**SB-10055923-4231**

**SERVICE CAMPAIGN BULLETIN**

NTB14-030c

**VOLUNTARY SERVICE CAMPAIGN  
2011 - 2013 JUKE TIMING CHAIN**

Figure 45a

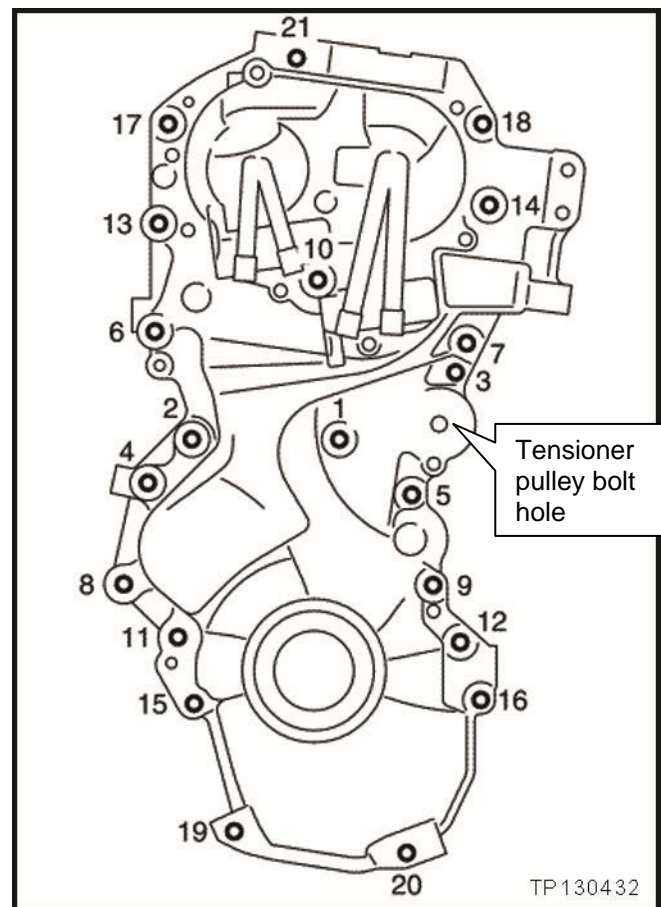
This bulletin has been amended. A caution for cleaning silicone from the front cover bolt holes was added on page 28. Please discard previous versions of this bulletin.

**CAUTION: Before installing the bolts for the front cover:**

- Clean excess silicone out of bolt holes 1, 3, 5, 7, 10, 15, 19, 20 (see Figure 45a).
- Also clean excess silicone out of the hole for the belt tensioner pulley bolt hole (see Figure 45a).
- Use a small flat blade screwdriver or other suitable tool to clean excess silicone from the bolt holes.

59. Install the front cover bolts shown in Figure 45a.

- Tighten the bolts in the order shown.
- Refer to the table below for torque specifications.
